R10RK

**SUBJECT: RECALL R10RK BATTERY CABLE ROUTING AT REAR OF
LARGE BATTERY COMPARTMENT**

Battery Cable Routing at Battery Compartment

Models Affected: 2010 All American (D3) Rear Engine Buses Equipped With Feature 00156-09 Heavy Duty Battery Compartment

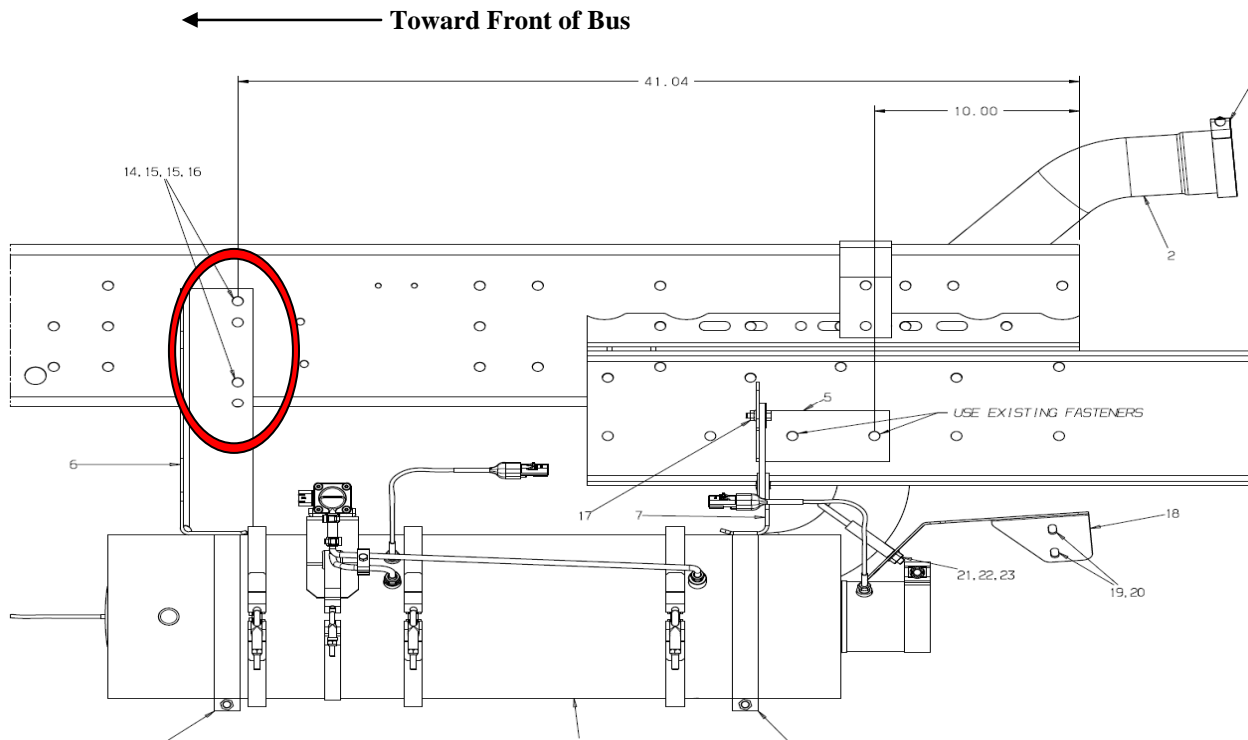
- 6. If any battery cables are pinched between the muffler mounting bracket and the front bottom side of the heavy duty battery compartment (See photos below) remove the clamps and zip strips securing cable, remove cable from between battery box and the muffler mounting bracket, remove loom and inspect cable for damage to insulation.

- 7. If cable is damaged, disconnect other end reference attached diagram D0003543), remove from chassis and replace w/new cable assembly.
- 8. If cable is pinched but not visibly damaged, then reroute cable to rear of heavy duty battery compartment and re-clamp/secure to hold in place per photo on page 1. Reference diagram D0003543 for cable routing.

Note: Cables must be routed/clamped to prevent contact with exhaust muffler. A minimum of 3 inches must be maintained between cables and exhaust muffler.

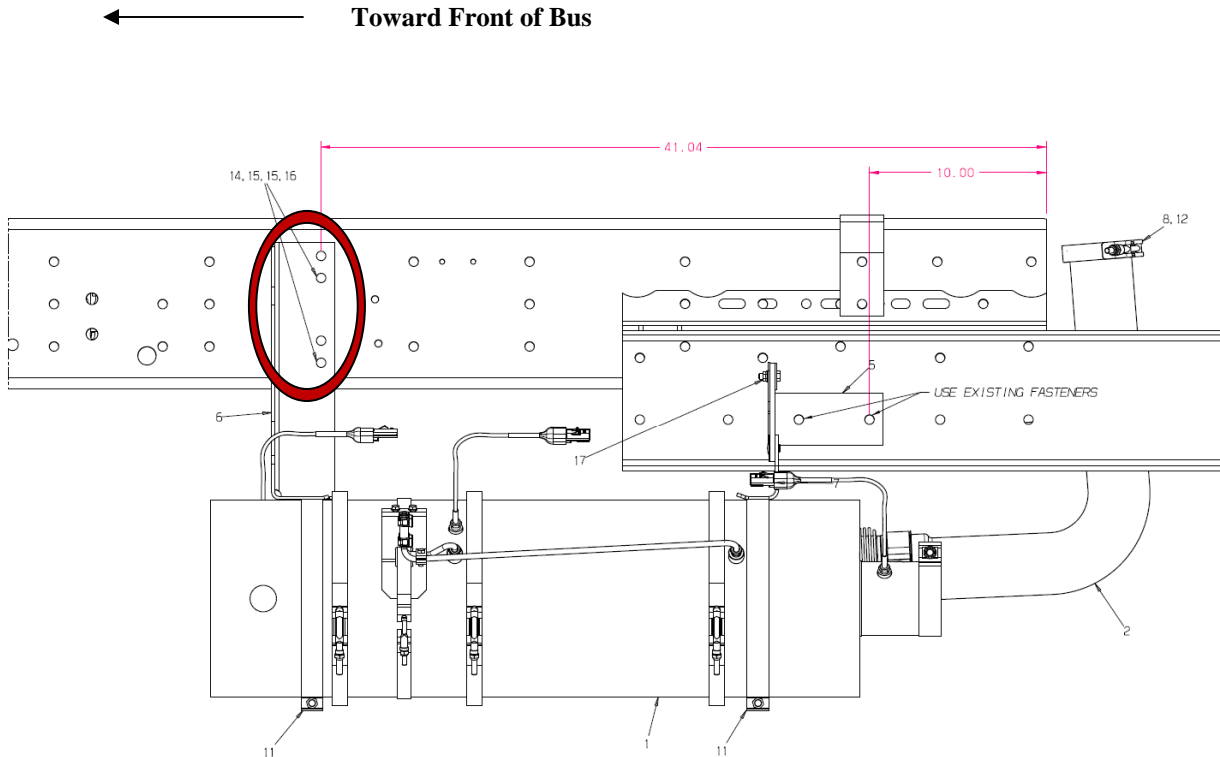
9. If exhaust muffler is contacting the battery compartment, relocate muffler exhaust bracket per diagram below for buses equipped with **Cummins ISB engines**.

Use **upper holes** in the bracket to mount to the **lower frame holes** at 41.04" from the end of frame. *Do not use the frame holes located at 40" from the end of frame.*
